Reference: PG&E Gateway Generating Station (00-AFC-01C)

Subject: PETITION FOR INSIGNIFICANT PROJECT CHANGE TO PLANT FACILITY

**PETITION FOR INSIGNIFICANT PROJECT CHANGE  
AT  
GATEWAY GENERATING STATION (GGS)**

DRAWING NUMBER: 065108-8STU-S1001

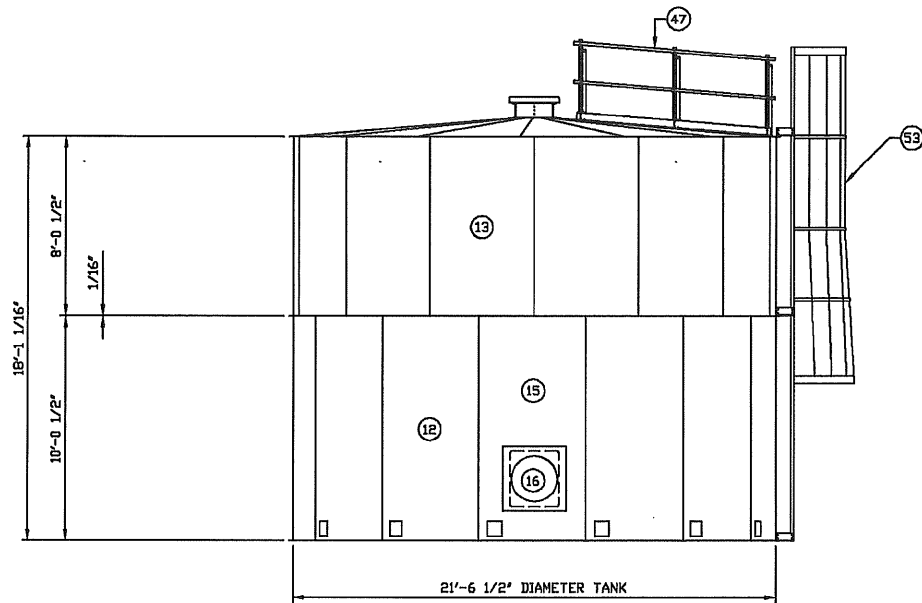
- a. **Description of Modification:** This modification proposes to install a new nominal 40,000 gallons bolted carbon steel storage tank, which is the same specification for the existing waste water storage tank at the facility. The proposed tank will be used to contain the additional volume of reclaimed water produced during the increased frequency of start-up/shut down activities. This modification also includes the installation of additional forwarding pump, valves, and interconnecting pipes. The new tank will be located near the existing 100,000 gallon reclaimed water tank (See attached Facility Layout.). Also attached is the Design Drawing for details on equipment specification.
